## PUBLIC SUMMARY

**Figure PS-1. Model of a spent fuel cask in routine, incident-free transportation and radiation dose to a member of the public. Relative sizes of the cask and person are approximately to scale.**

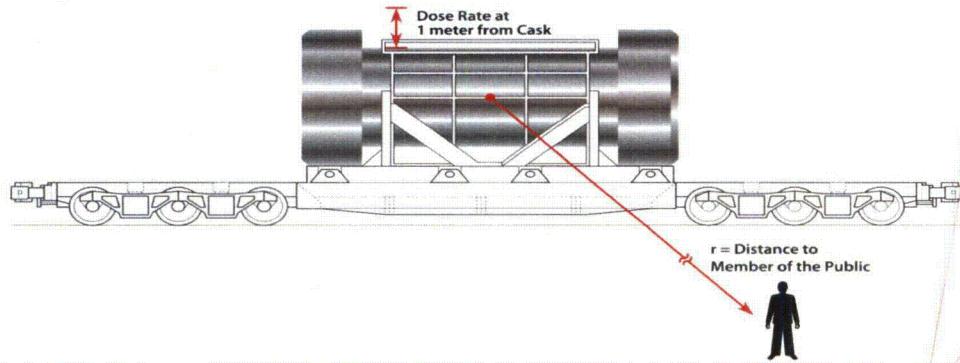
**Comment [s9]:** Figure PS-1: The portion of the figure schematically showing the "Dose at 1 meter from Cask" seems totally irrelevant since the Public Summary does not discuss the significance of this distance nor how the dose at this distance is used. (CParks)

**Comment [csb10]:** You state that shipments will be mostly by rail and the diagram PS-1 is of a rail scenario, and yet you present results from a "truck" scenario. Would recommend trying to be consistent.

**Comment [csb11]:** There really is no context for this diagram. Would recommend putting units in this diagram, and providing a few text boxes (on the figure) that explain what it means.

**Figure PS-2. Collective Doses from Background and from a Truck Shipment of Spent Nuclear Fuel (Person-Sv)**

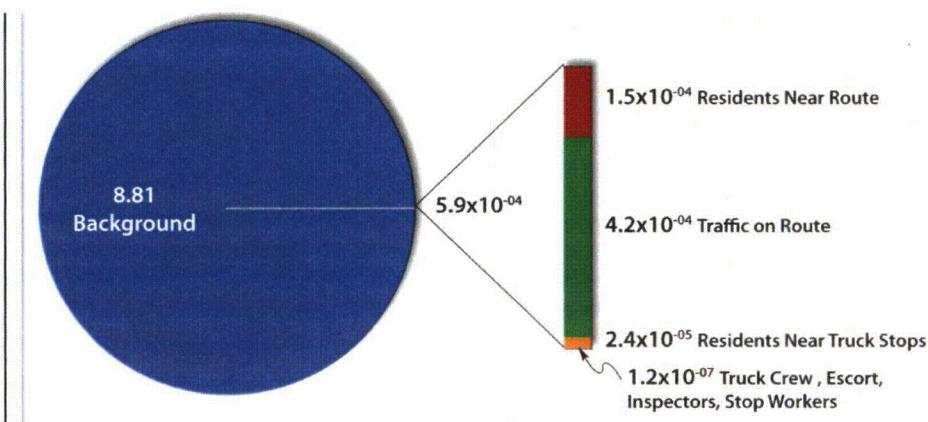
**Comment [s13]:** It would be useful to include somewhere the description of the collective doses presented in Fig PS-2 the number of people considered for each component of the collective dose (i.e. how many "Residents Near Route," etc. are assumed).

**Comment [s14]:** 1. The figure captions need to be informative about the information in the plot, e.g. the figure caption for PS-2 indicates this is for a truck shipment, the text indicates this is for a truck shipment from Maine Yankee Nuclear Power Plant to Oak Ridge National Laboratory - this detail is important.

**Comment [s15]:** The collective dose value of  $5.9 \times 10^{-4}$  is given in both figures PS-2 and PS-3, the first says this is a "truck shipment" which from the text is the Maine Yankee to Oak Ridge route and the latter "routine truck transportation" which is an average over 16 routes according to the text. Are these the same transportation scenarios? It is not clear from the figure captions.

**Figure PS-3. Collective doses (person-Sv) from routine truck transportation.**

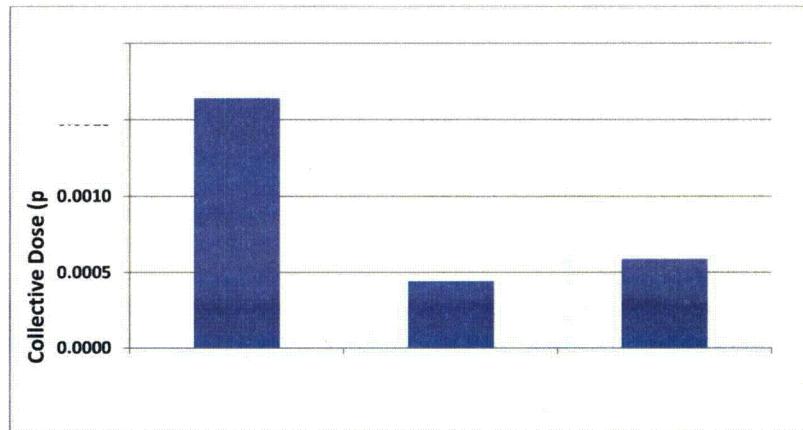
**Comment [h16]:** How do the 16 routes chosen represent a bounding or representative set of potential doses? Most polls indicate that the public is generally in favor of nuclear power (which I suspect extends to nuclear fuel shipment) so long as it's not done "in my backyard". Given this general attitude and the fact that criticisms are continuously levied about the number and nature of the increased spent fuel shipments (and routes), some discussion of how these were selected and how they represent at least a similar set of routes (for comparison purposes) as previously considered or a representative sample would be useful in this summary. This would help ensure the charge that a judicious set of routes were chosen to ensure the doses/risks were favorable could not be levied.

**Comment [s17]:** Border missing from bottom of chart. There needs to be a hyphen between NUREG and 0170 to be consistent with rest of report.

**Figure PS-4.** Corner impact onto a rigid target at 97 kph (60 mph) accident scenario for a spent fuel cask and the deformations produced by the impact.

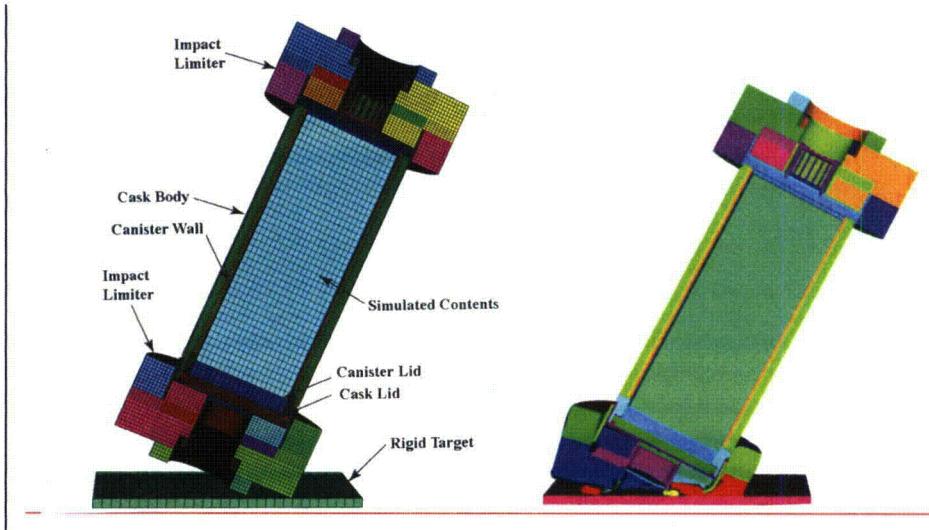
**Comment [MF20]:** Note: on some printers, this figure does not print. Other printers it seems fine.

**Figure PS-6.** Accident collective dose risks from release and LOS accidents. The LOS bar representing the NUREG/CR-6672 collective dose is not to scale.

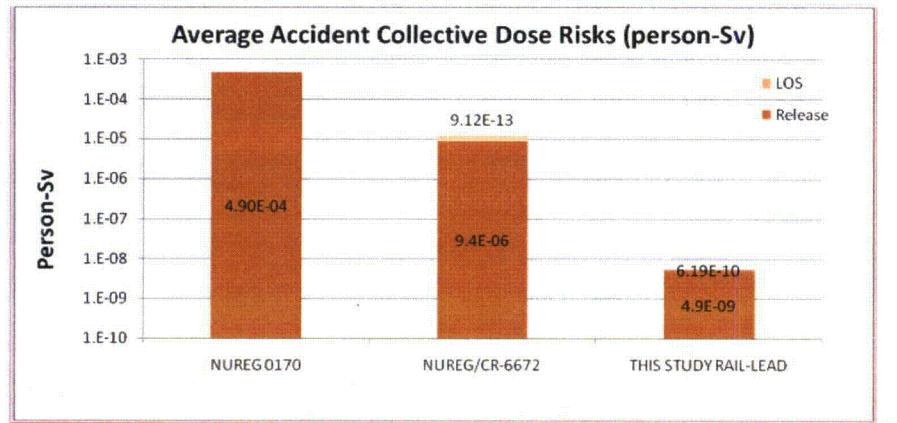
**Comment [h29]:** CLARIFICATION: What are the values above the columns for NUREG/CR-6672 and "THIS STUDY RAIL-LEAD"? are the numbers above the columns the loss of lead shielding values? Is that why there is no value above the NUREG 0170 column?

[Figure 1 \(Drop test of cask with associated minimal damage\)](#)

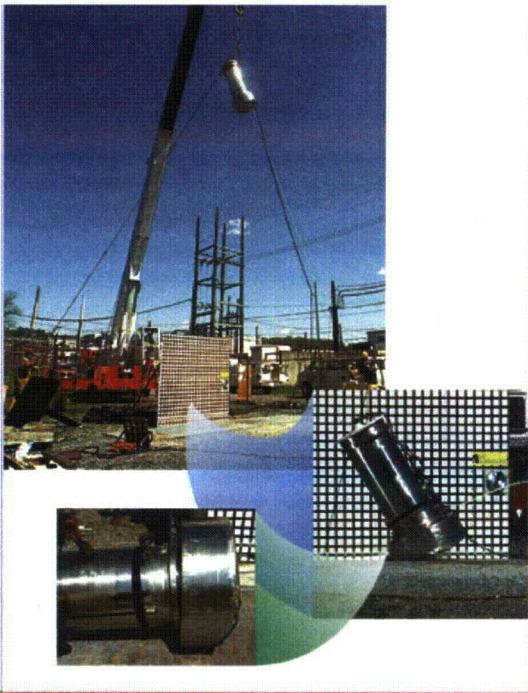
**Comment [h46]:** Added this and the Figures below. Please note – figures are for example purposes – SNL may wish to use other figures.

**Comment [csb47]:** Not sure if this is a spent fuel package.
